STAFF REPORT: 2/8/2023 REGULAR MEETING

APPLICATION NUMBER: #23-8201

ADDRESS: 761 WHITMORE

SCOPE: INSTALL VINYL WINDOWS, REPLACE DOORS (WORK COMPLETED WITHOUT APPROVAL)

Figure 1, by applicant, showing proposed 4 entrance designs, 6 door type designs for all 14 doors. See also drawing A700

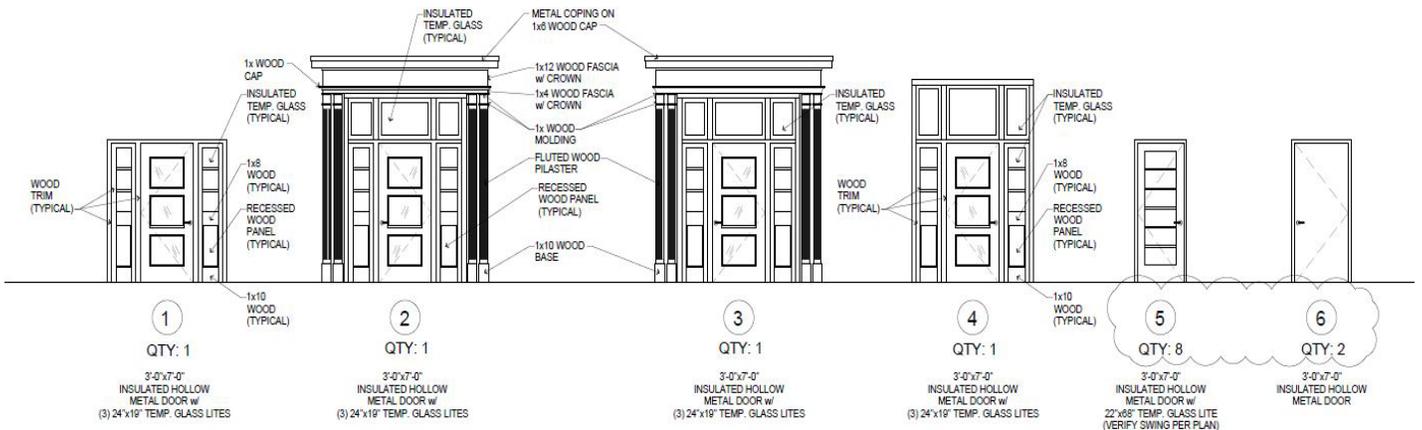
- Staff observed that the original wood doors for the four entrances had a 3x6 glass configuration over wood paneling. The applicant's design reduces the configuration to 3 glass panels for the four front entrances, which changes the configuration of their original design. It is staff's opinion that changing the original door material from wood to metal will not cause an adverse impact and is an appropriate material. However, it is staff's opinion that the configuration and scale of the glass panels can be more appropriately designed to their original configuration to approximate the scale, design or arrangement of the 3x6 original glass configuration. Staff has no issue with the patio door's 6 panel glass configuration or the solid configuration for the two utility doors.

- While staff has no issue with the proposed door entrance design and materiality, staff does offer the opinion that the four front door's window configuration, which contribute to the character defining features of the mid-century modern architecture and the adjacent pattern of the side lites, could be more appropriately designed to resemble the 3x6 glass panel arrangement of the original front entrance doors.

- Applicant supply HDC staff with modified design for the four front entrance doors' window configuration for approval and before installation.
